Red Line Master Schedule

Version 10.7 Analysis

Doc ID	Project	Entity	Line	Package	Doc. Type	Chrono NO	Version
Code:	8162	ERA	RED	CMN	TRP	120325	C

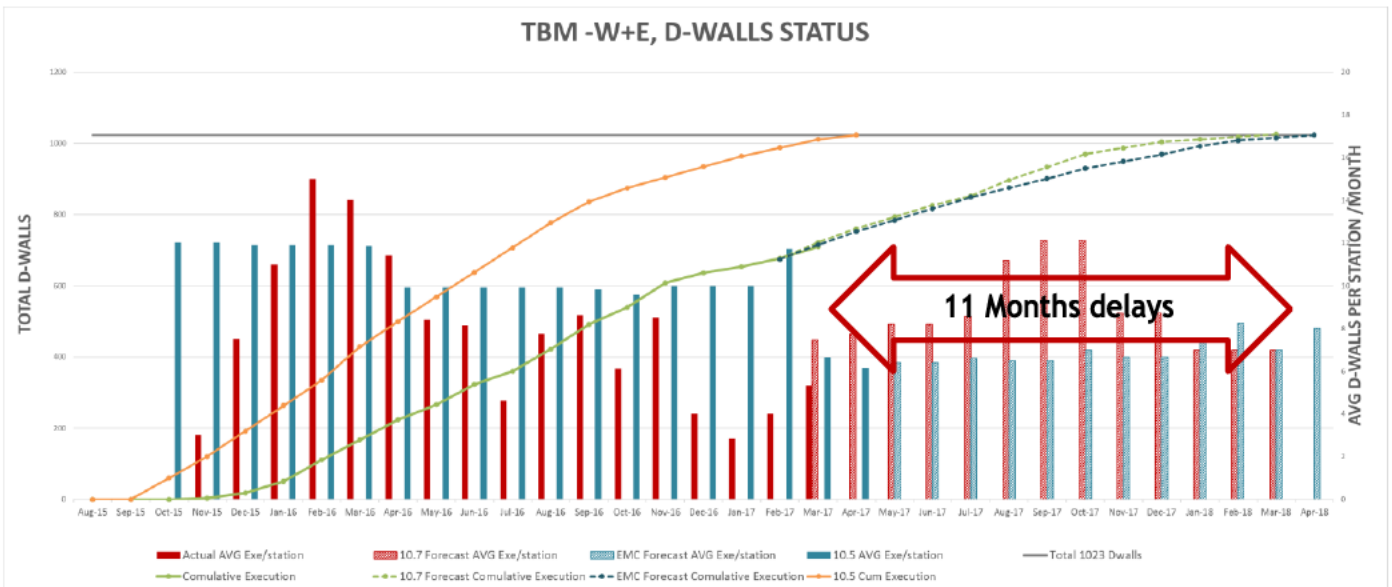
The graph below shows the change made in the D-walls execution between sch 10.5 according to which the contractors (TBM W and TBM E) has planned their progress and the 10.7 schedule and EMC forecast.

The graph follows the execution of the D-walls from the beginning of the works. A lower rate of execution than planned can be seen throughout most of the months. As a result, the execution period is extended by 11 months (from April 2017 to March 2018). Additionally, the graph reflects low execution rate in the past months (Dec 2016 - Jun-Feb 2017).

Since the D-wall construction activity is a main task in the stage C of the project, any execution delay may delay the end date of the project. The mitigation for the D-walls delay was to change the construction sequence to TBM 1st, it consumed Buffers and increased the execution rate.
